PIKE TOWNSHIP FIRE DEPARTMENT

RE: Variance 17-05-13
Day Early Learning
5735 W. 73rd St
Indianapolis, Indiana 46268

Dear Commission Members,
Pike Township Fire Department has reviewed the above variance request that is based on orders to correct violations written on January 23rd, 2017.

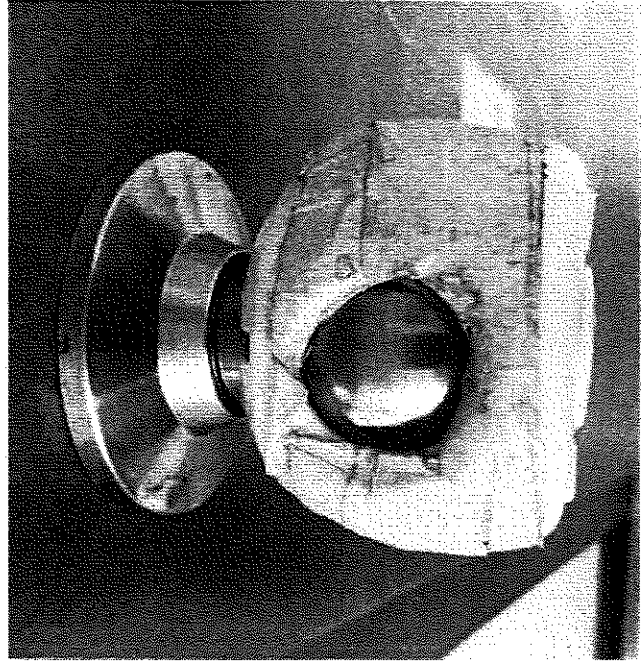
In addition we do not support the request to grant a variance on the requirement of their window blinds not complying with the flame spread and smoke generations requirements of 807.1 of the 2014 Indiana Fire Code. 675 IAC 22-2.5

807.1 General requirements. In occupancies in Groups A, E, I and R-1, and dormitories in Group R-2, curtains, draperies, hangings and other decorative materials suspended from walls or ceilings shall meet the flame propagation performance criteria of NFPA 701 in accordance with Section 807.2 or be noncombustible.

Window blinds are made up of a plastic or vinyl material.

Non Code Compliant
Hardware

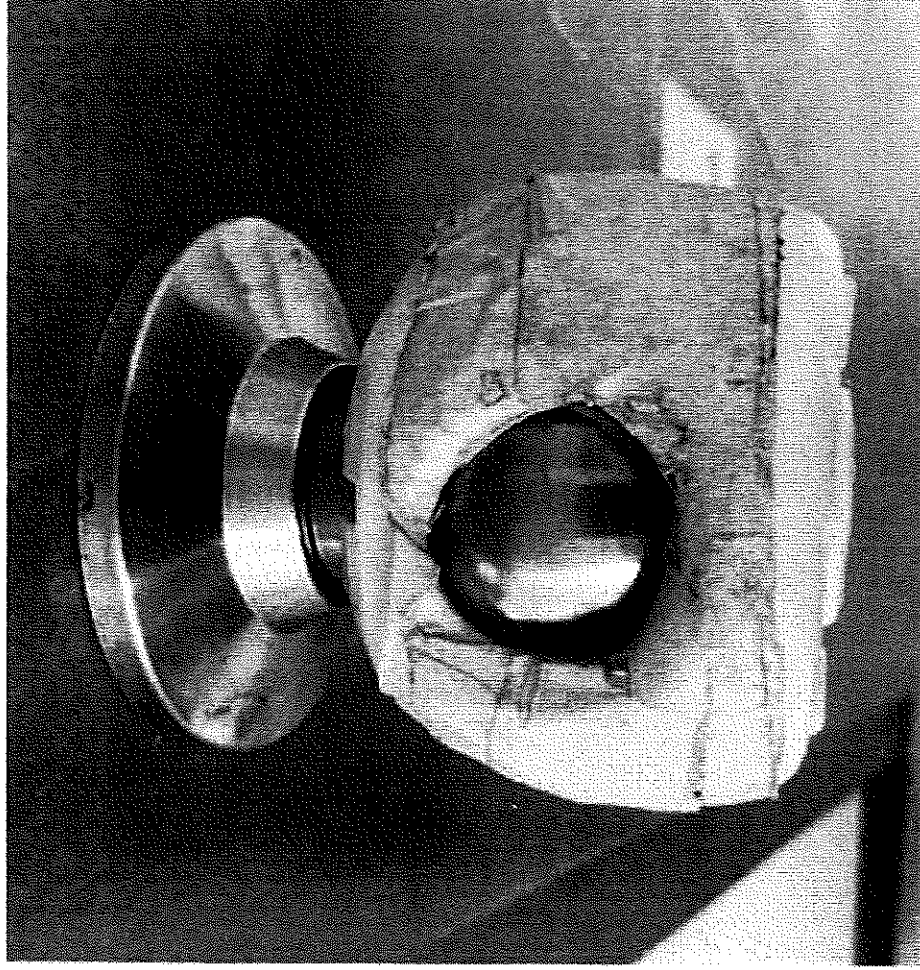
[B] 1008.1.9.1 Hardware. Door handles, pulls, latches, locks and other operating devices on doors required to be accessible by Chapter 11 of the *International Building Code* shall not require tight grasping, tight pinching or twisting of the wrist to operate.

[B] 1008.1.9 Door operations. Except as specifically permitted by this section egress doors shall be readily operable from the egress side without the use of a key or special knowledge or effort.

Less than 20% of door knob
surface can be TIGHTLY GRASP to
open exit doors

Code Compliant
Hardware

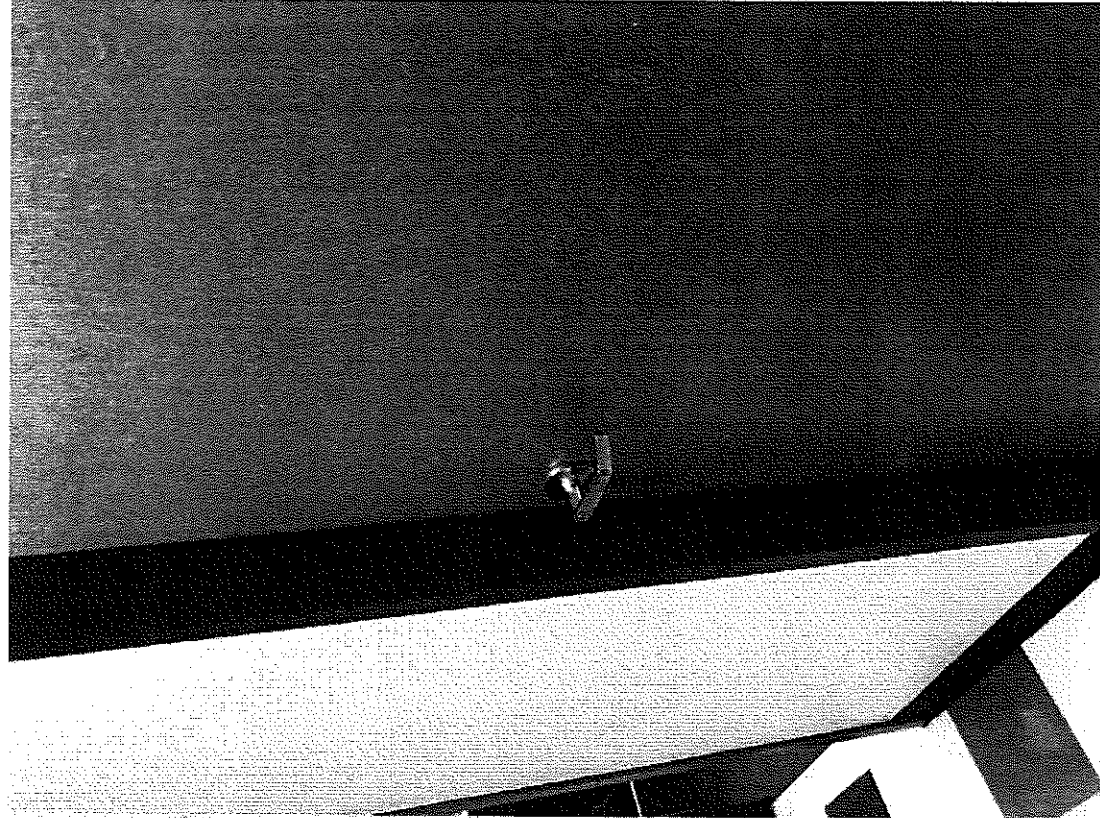
Pike Township Fire Department remonstrates against any variance that would make an exit door difficult to open. The means of egress design is very important to the evacuation of a building. Exit doors hardware is intentionally designed to make doors easy to open and to accommodate people in our community that have disabilities.
